## **Appendix N      Consultation document and banners**

In November 2021, Sunnica Ltd applied for development consent to build Sunnica Energy Farm ('the Scheme'). We are now seeking to make some changes to the proposals for connecting to the national electricity transmission system included in our application for a Development Consent Order (DCO).

## Summary of the changes

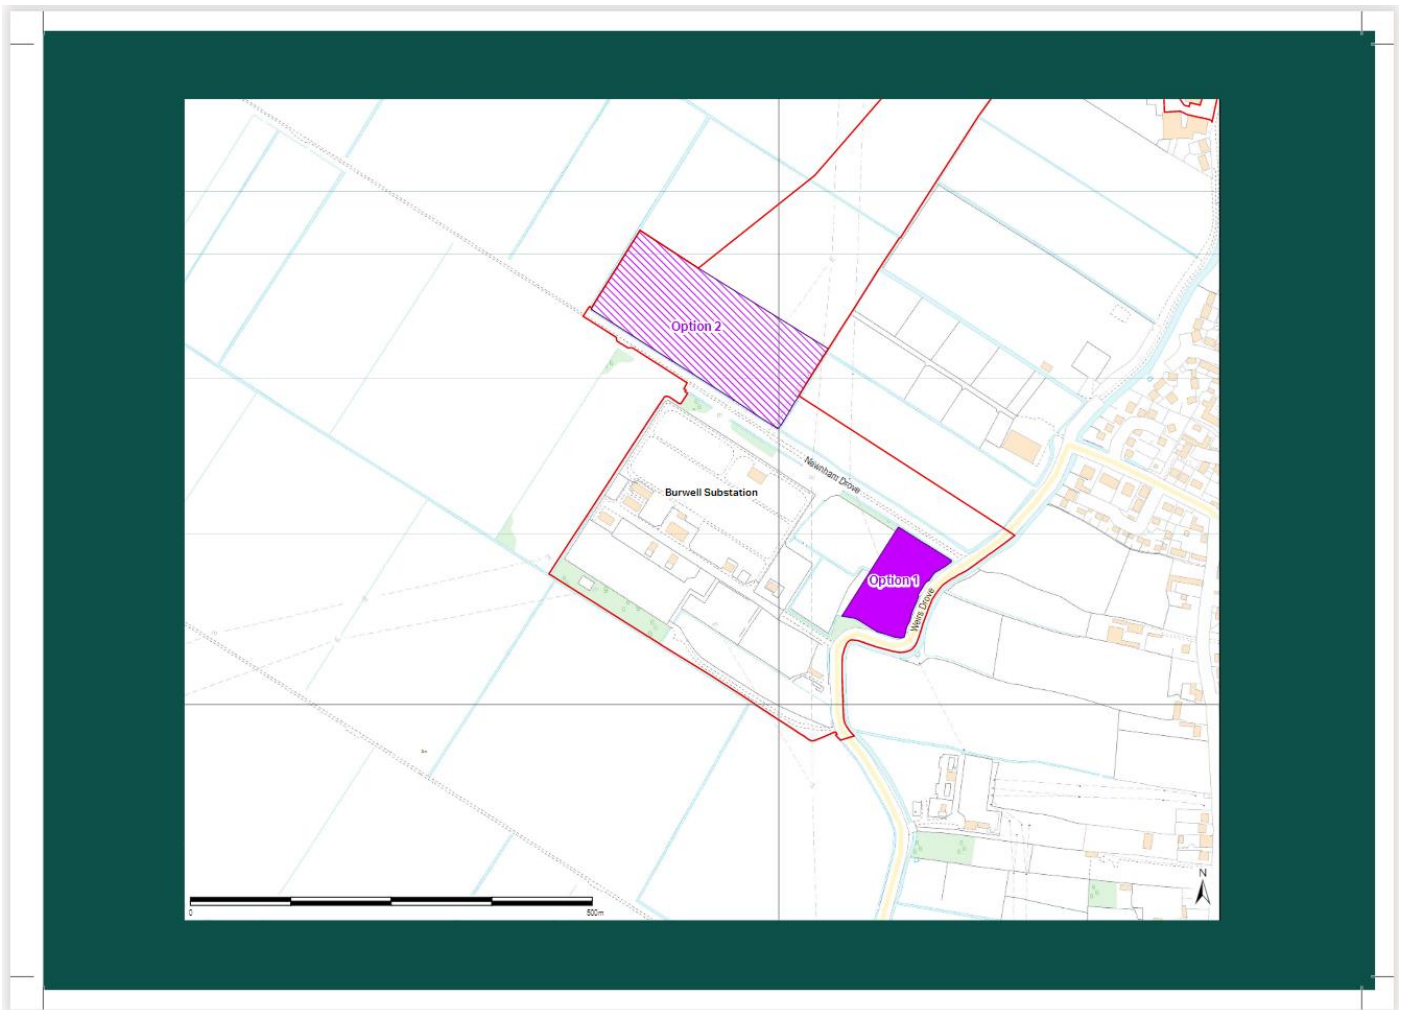
NGET has subsequently stated that our Option 1 substation extension is: "not

technically feasible given the amount of land now required by the Promoter, the planned extension of the substation and [National Grid Electricity Transmission] NGET's license obligations". As such, the representation suggested that we should take forward Option 2.

Subject to receiving confirmation in writing from NGET as to why Option 1 is not technically feasible, we will remove Option 1 from the Scheme as part of our change application. Subject to agreeing the modification agreement with NGET, which is likely to be post commencement of the Examination, we would remove Option 2 from the Application. Accordingly, it is anticipated at this stage that the changes application will retain Option 2, but remove Option 1

### **Change 2**

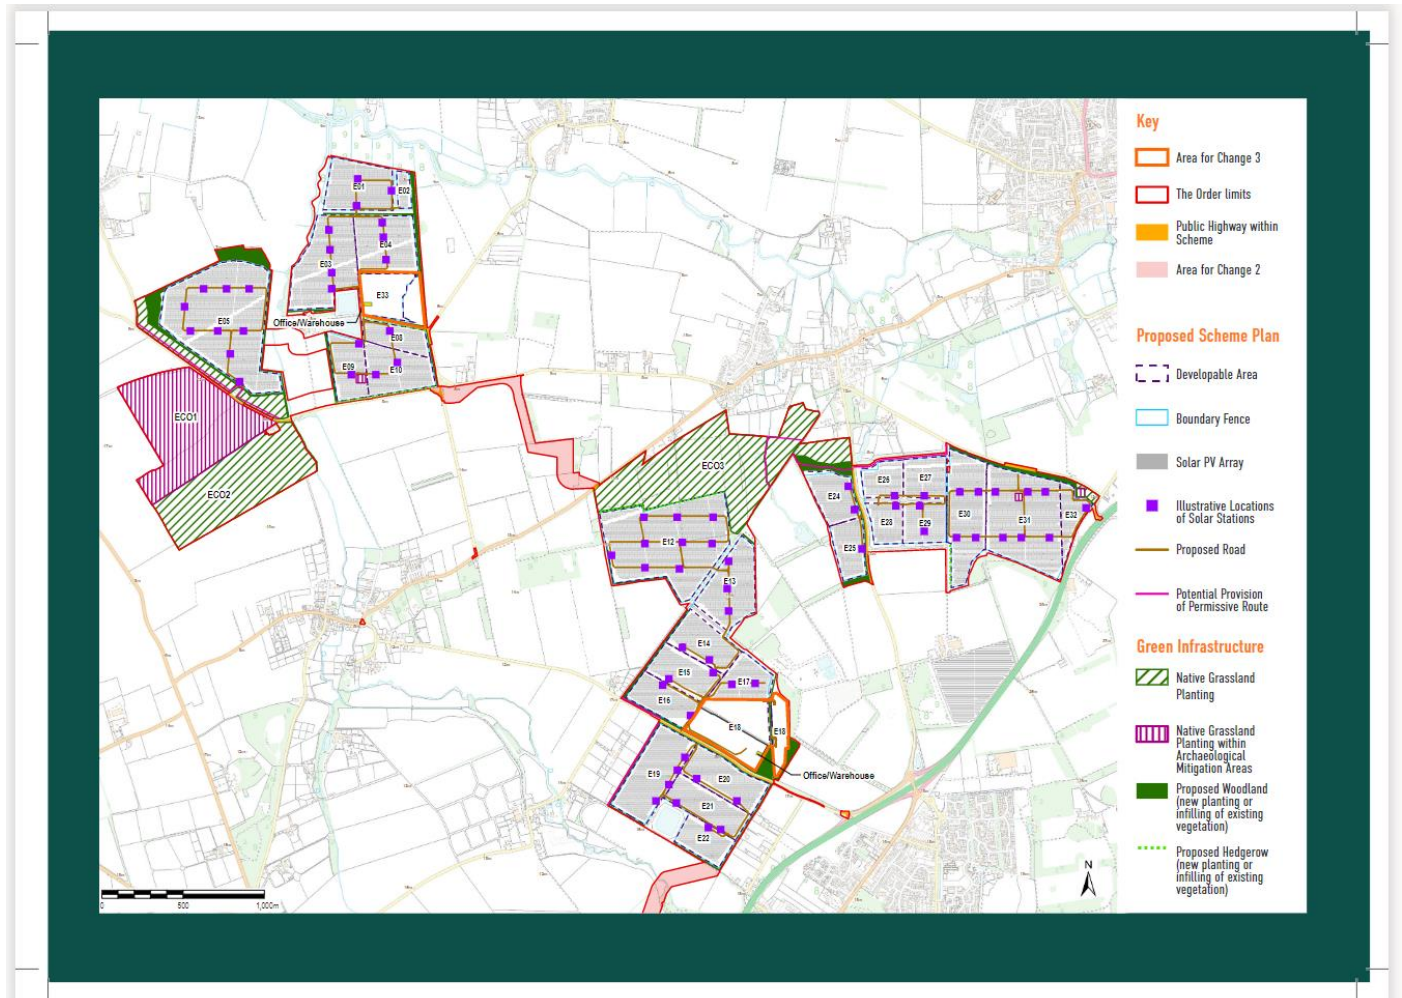
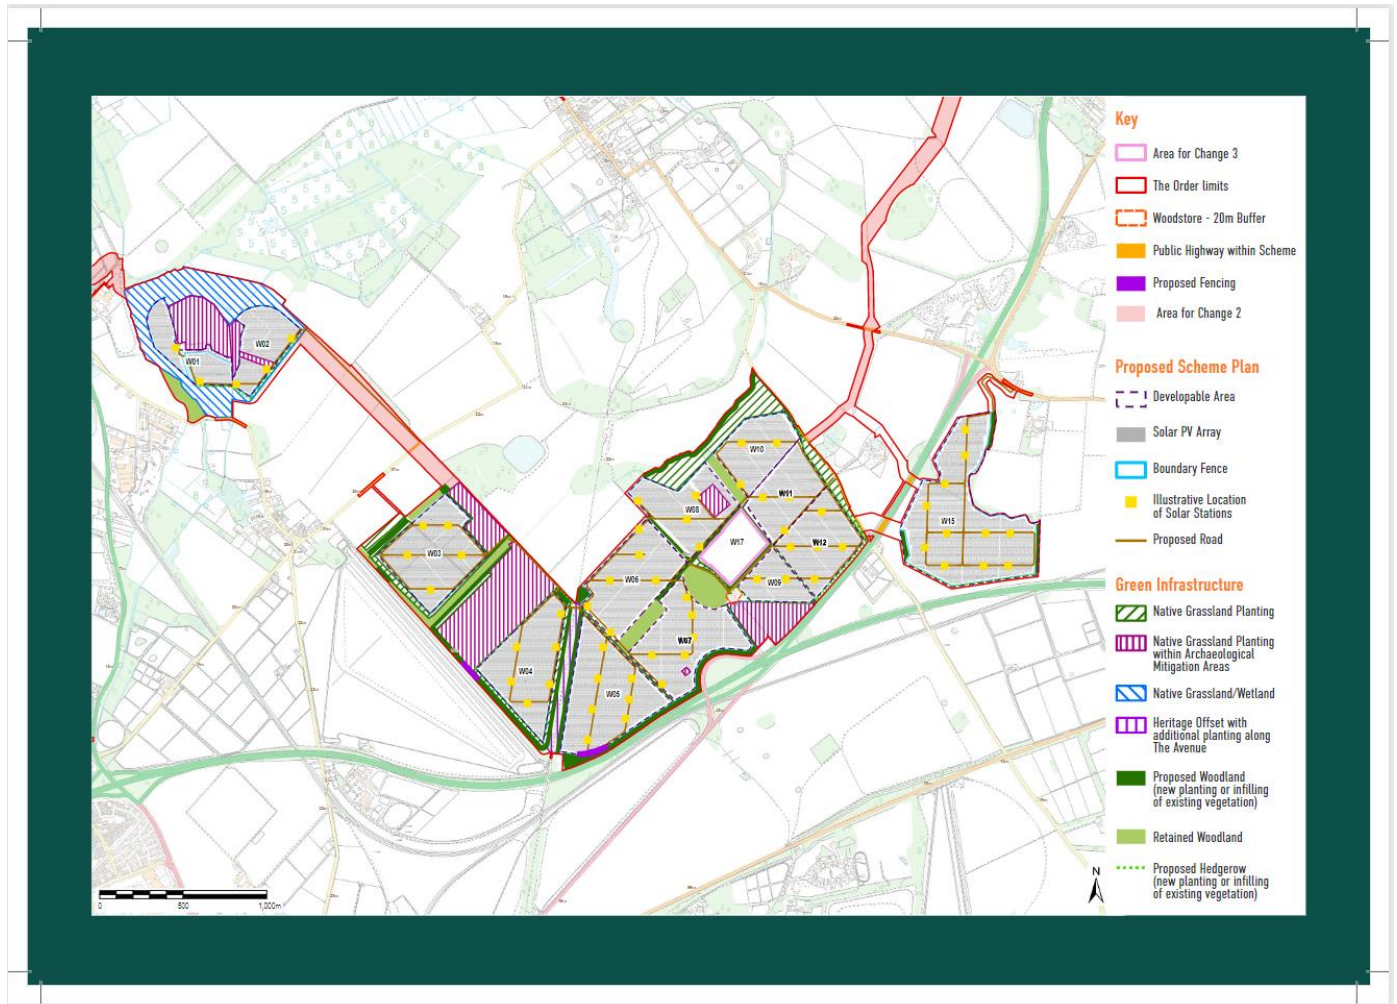
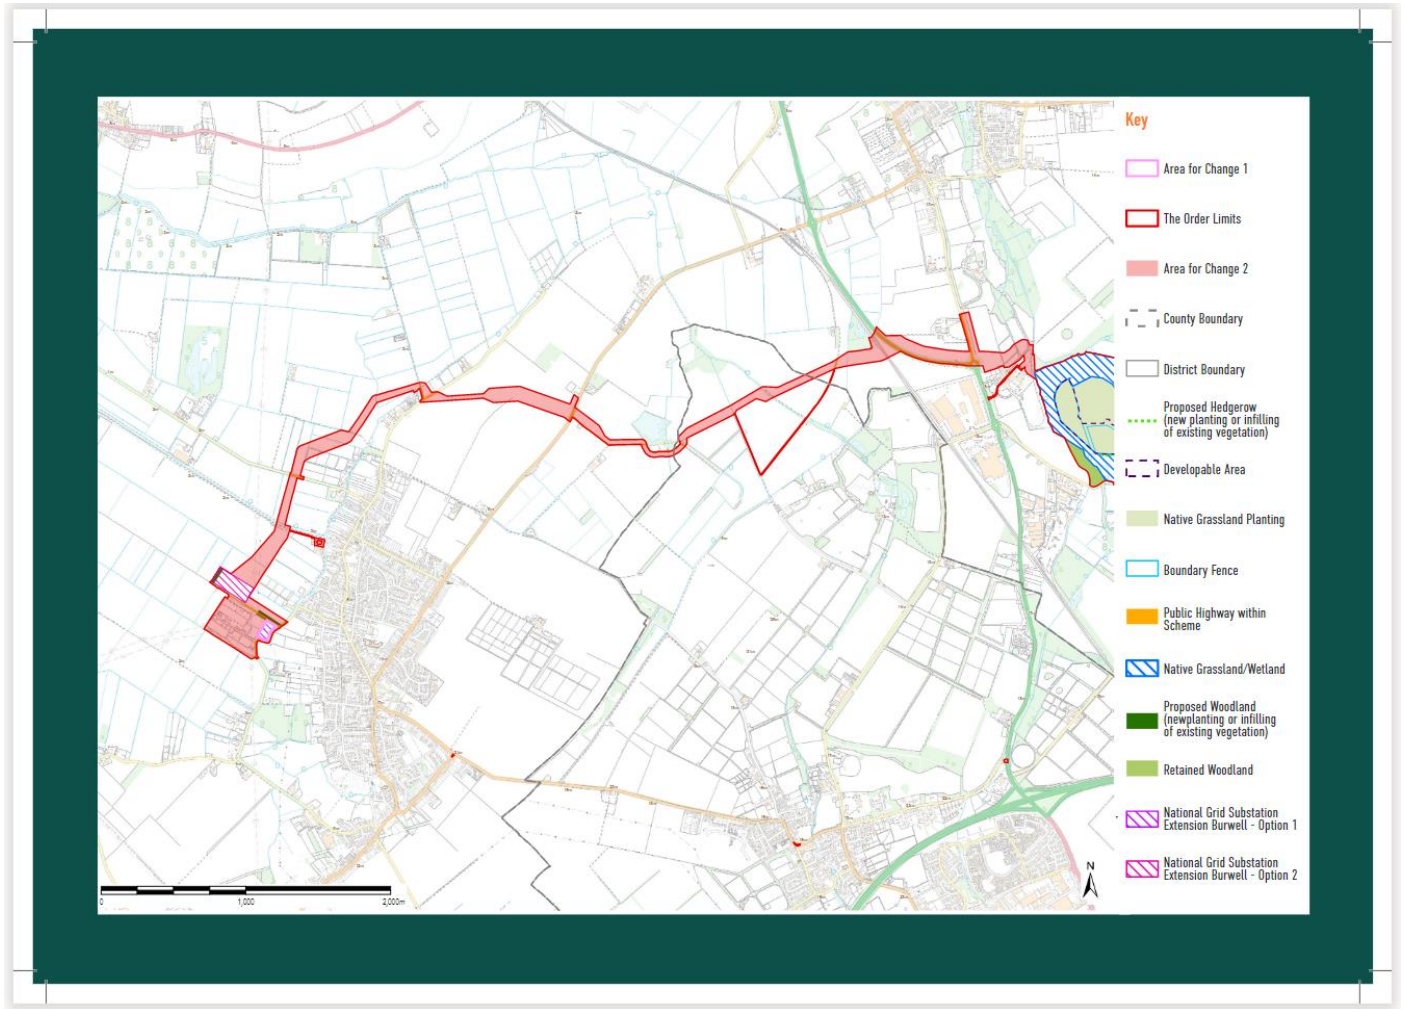
Option to be added to the Application to enable the use of 400kV cabling within the grid connection routes A and B.

Amendments will be required to Schedule 1 of the Draft Development Consent Order [APP-019] to add 400kV cables to the definition of 'electrical cables' for Work No.4. No changes will be required to the Land and Crown Land Plans [APP-006] as the existing cable corridor width within the application would remain unchanged.
